Access Compliance Report Public Rights-of-Way (Curb Ramps)

Intersection ID: N/AMain Street:E_PROVIDENCE_RDCross Street:N/ALocation:NWADA ID: AAFEF8FA3D20Ramp Type:PerpDiagInitial Pass/Fail:FailOverall Compliance:NoSeverity Score:25

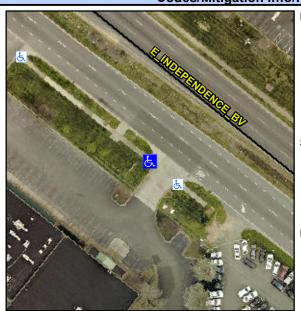
Not Found, R304.2.2, R304.5.3

Compliance Description		Data	ata Compliance Description		Data
1	N/A	Ramp Length (in)	48.0	No	Ramp Slope (%)	8.9
١	⁄es	Ramp Width (in)	48.0	No	Ramp XSlope (%)	6.1
N	N/A	Flare Type LT	N/A	N/A	Flare Type RT	N/A
1	N/A	Flare Slope LT (%)	N/A	N/A	Flare Slope RT (%)	N/A
1	N/A	Flare Traversable LT?	N/A	N/A	Flare Traversable RT?	N/A
1	N/A	Landing Length (in)	N/A	N/A	DWS Provided?	N/A
1	N/A	Landing Width (in)	N/A	N/A	DWS Contrast?	N/A
1	N/A	Landing Slope (%)	N/A	N/A	DWS Length (in)	N/A
١	N/A	Landing X Slope (%)	N/A	N/A	DWS Full Width?	N/A
1	N/A	Landing Curb? (Y/N)	N/A	N/A	DWS Offset (in)	N/A
1	N/A	Shared Landing?	N/A			
1	N/A	Gutter Ponding?	N/A	N/A	Gutter Slope (%)	N/A
N	N/A	Gutter Lip Ht (in)	N/A	N/A	Gutter X Slope (%)	N/A
1	N/A	Painted X Walk1?	No	N/A	Painted X Walk2?	No
		X Walk 1 Direction	To SE		X Walk 2 Direction	To NE
1	N/A	X Walk 1 Width (in)	N/A	N/A	X Walk 2 Width (in)	N/A
		X Walk 1 Slope (%)	0.6		X Walk 2 Slope (%)	5.5

Remove & Replace Curb Ramp With Two New Directional Ramps or Equivalent.
